Staff Report to the Zoning Administrator

Application Number: **05-0486**

Project Description: Proposal to reconstruct a single-family dwelling utilizing the existing foundation and to construct an addition to include a family room and a garage, and to demolish the existing third story and swimming pool.

SPITTERS RESIDENCE - 143 PUFFIN LANE

1" = 10' OPTION 3A

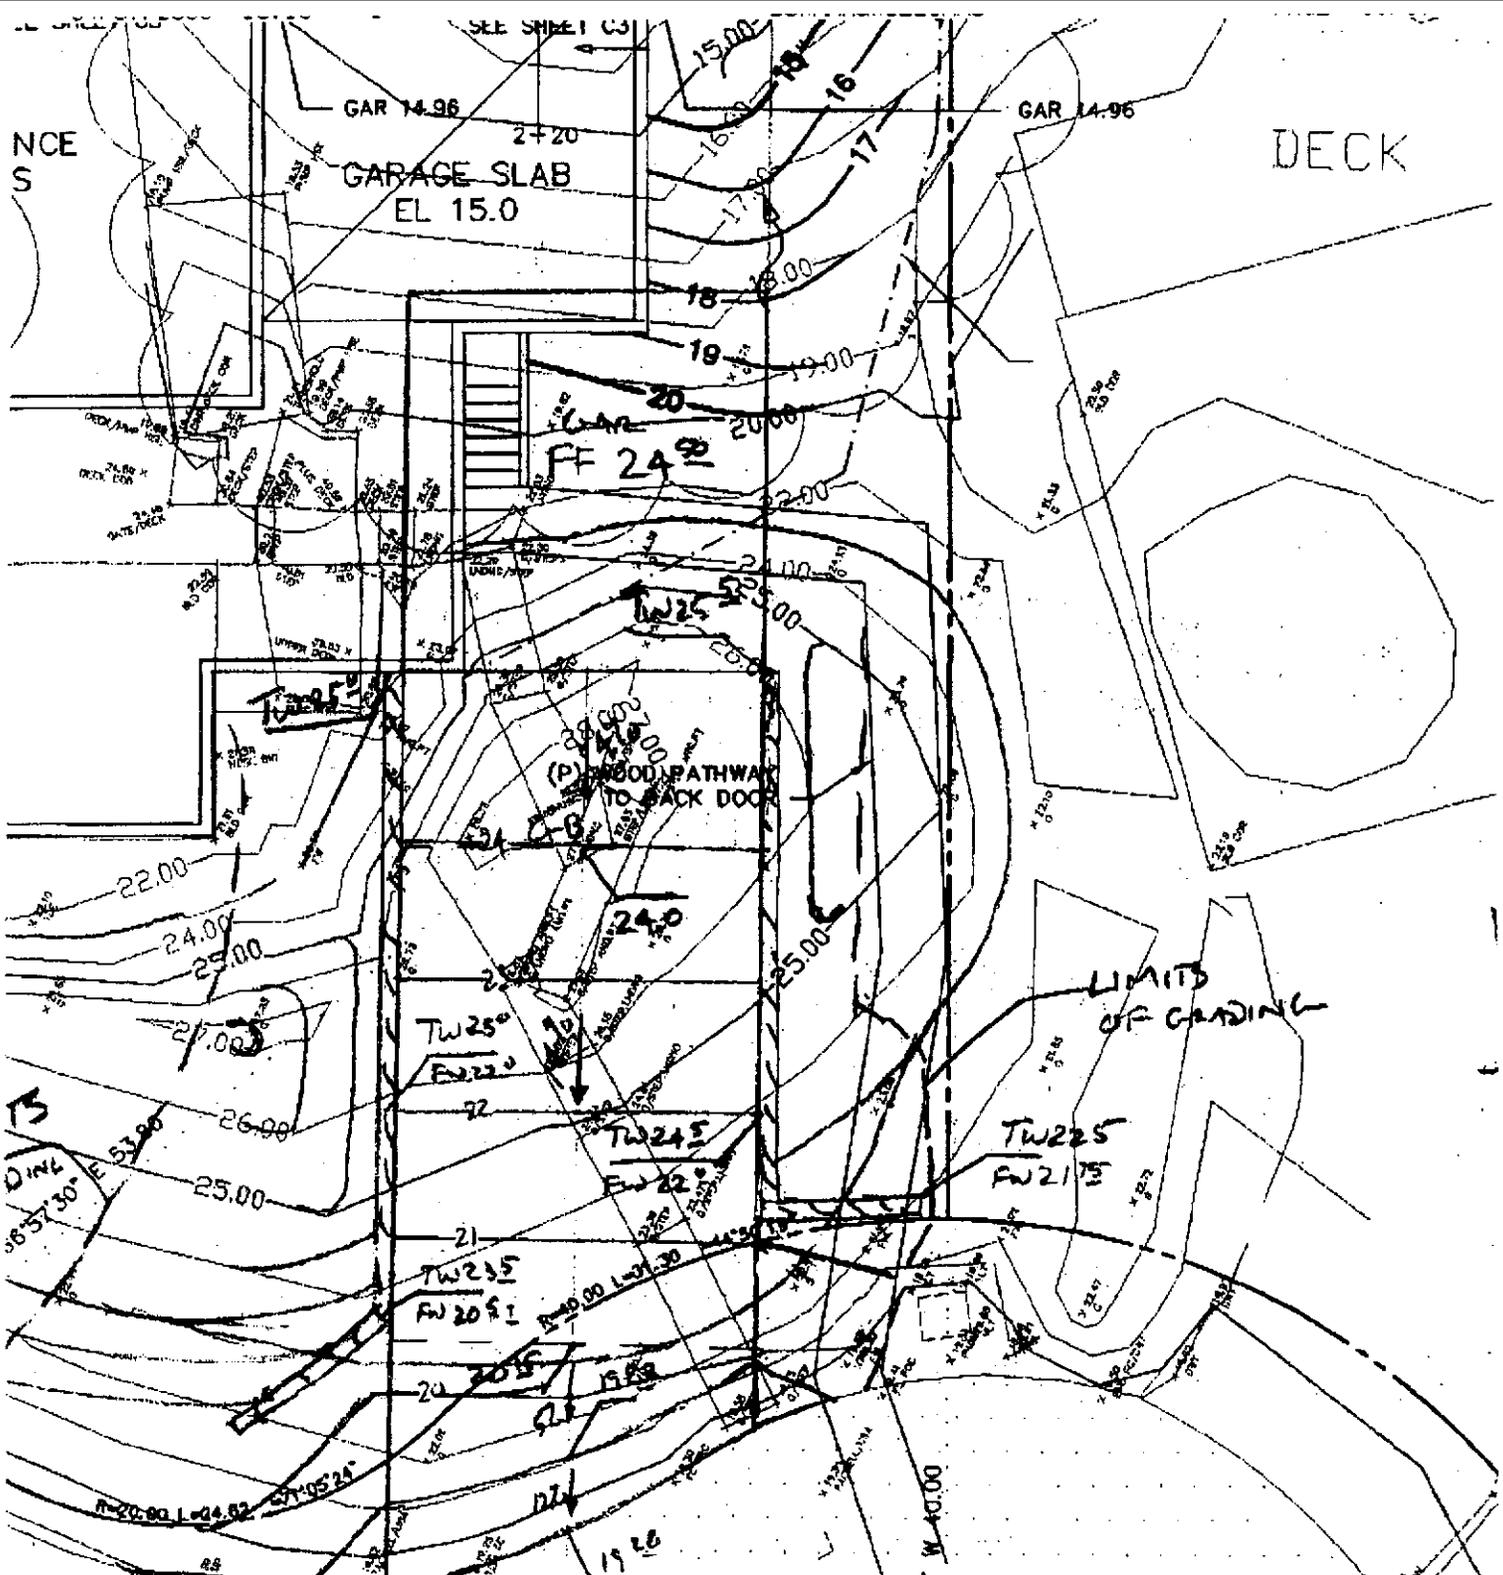
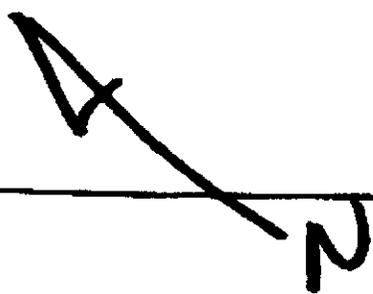
Plans submitted contained three driveway options discussed in our meeting with the architect and owner on 4/6/05. EP still does not approve of "Option 1" which the owner desires. EP has reviewed the other two options and the department can support "Option 2". This option minimizes the grading volume and has the least amount of overall ground disturbance.

SECTION A-A
PERCOLATION TRENCH/LEVEL SPREADER

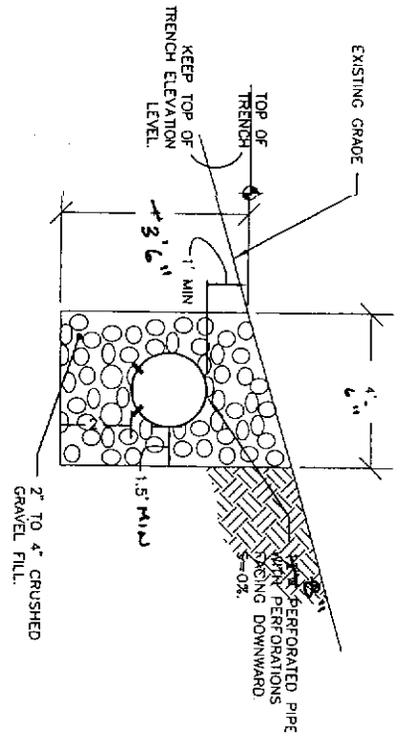
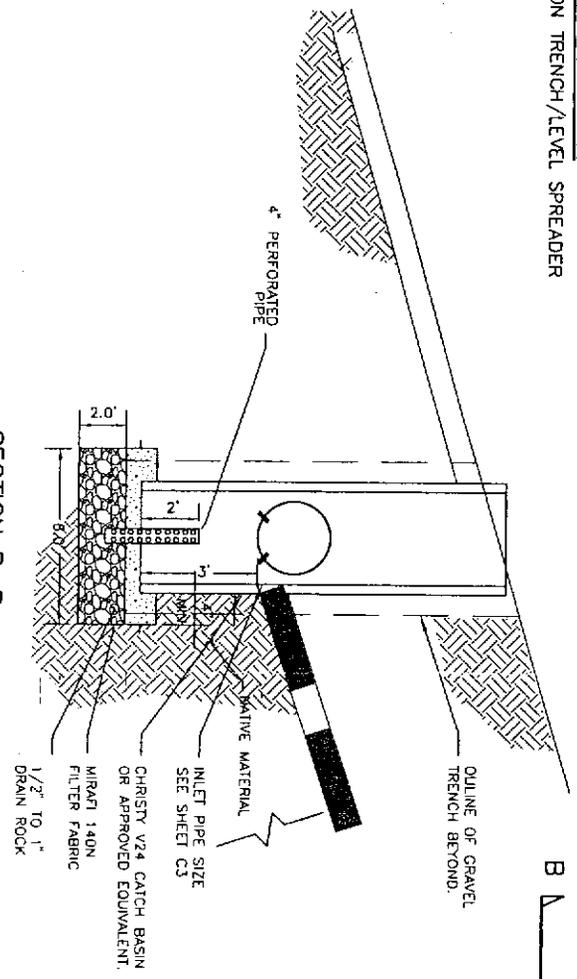
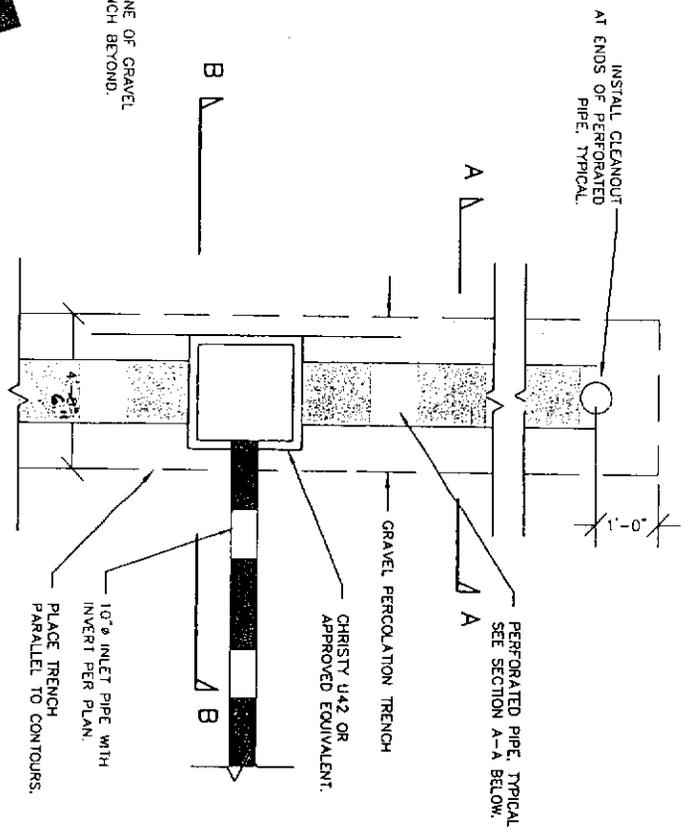
2) Add retention details shown on sheet C3.1 in Drainage Analysis & Stormwater Management report to plans.

3) Plan View detail on sheet C3.1 in Drainage Analysis & Stormwater Management report shows pipe from driveway perpendicular to retention trench which is opposite to layout depicted in plans. Please match detail to layout shown on sheet C1 of plans.
